HISTORIC DISTRICT COMMISSION ADDITIONAL INFORMATION REQUEST

Application Number: HDC2025-00495

**REBUILD REAR
SECTION OF HOME**
899 EDISON
DETROIT, MI
48202

Subject: Structural inspection of two-story structure at rear of dwelling at 899 Edison Ave. in the City of Detroit, MI

**EXISTING
ELEVATIONS**

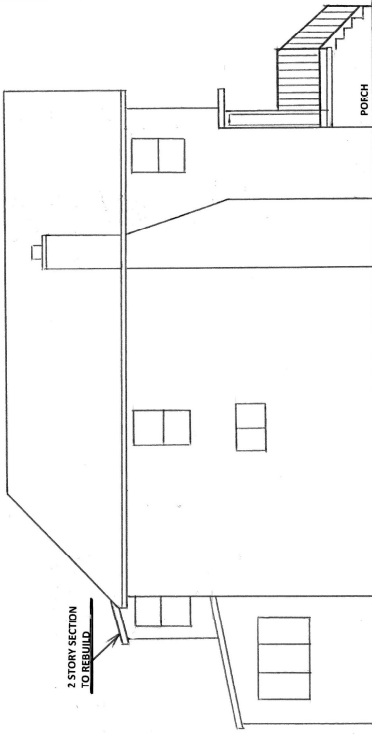
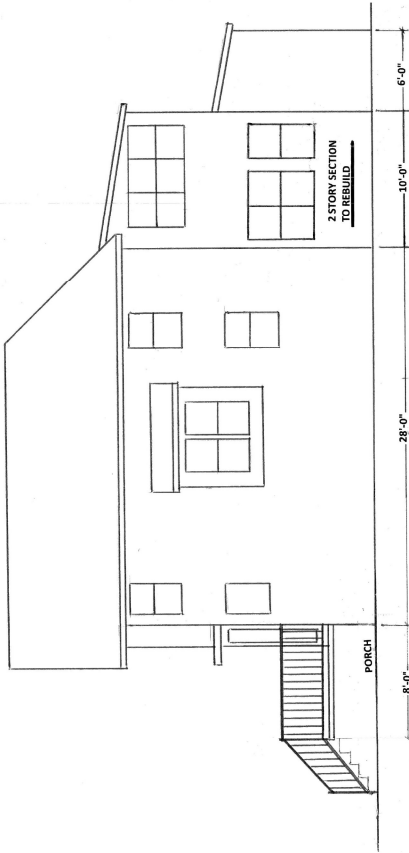
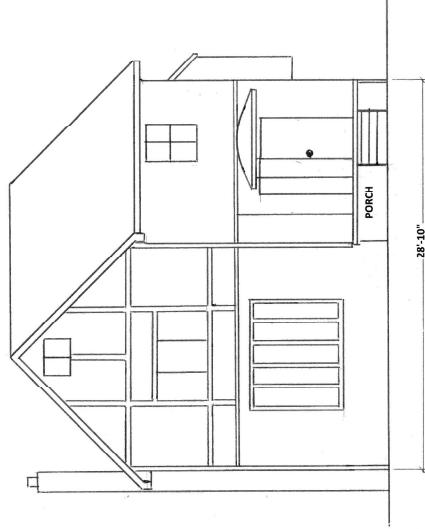
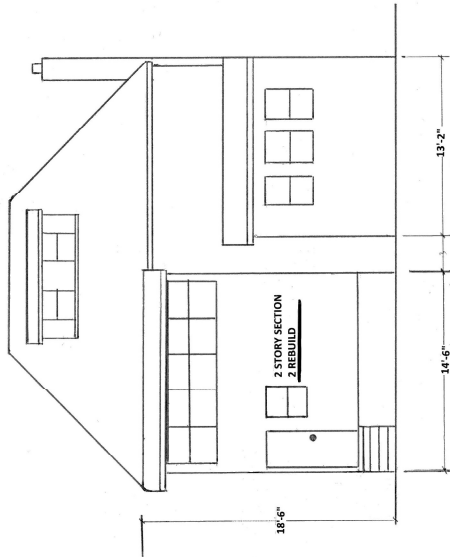
The two-story porch with the stucco and wood windows is a distinctive character-defining feature of the house. I recommend obtaining a structural assessment from a licensed engineer, as the Commission will likely not consider this demolition if they don't have documentation that this component of the house is deteriorated beyond repair.

Regarding the existing drawings, I am confused by the small elevations at the top of A-101. Are these trying to show how the new construction will look upon completion? If so, they don't show any exterior doors, however cut sheets of a single door and a vinyl sliding door were submitted. You also mention replacing vinyl with cedar shingles; however, the small drawings specify vinyl siding. Would the stucco finish at the second floor be replicated?

The submitted drawings are not sufficient to show how this two-story extension will look upon completion. I have attached examples of detailed, dimensioned drawings - specifically a floor plan and elevations - as a guide for what is needed for the Commission's review.

Thank you for taking the time to review my submitted proposal. I have attached an updated drawing showing the work to be done from our architect and a written review of an inspection by our structural engineer. We have our second baby due in May and we need to ensure that this structural problem near the new baby room will be fixed. It has taken months searching and paying for help through the recommended websites you've sent me with brick+beam to get to this point and we have not moved in fixing a problem that gets worse every season. I hope this is all we need to move forward with our plans to ensure the house of my wife and child is a meager "structurally sound," let alone renovated.
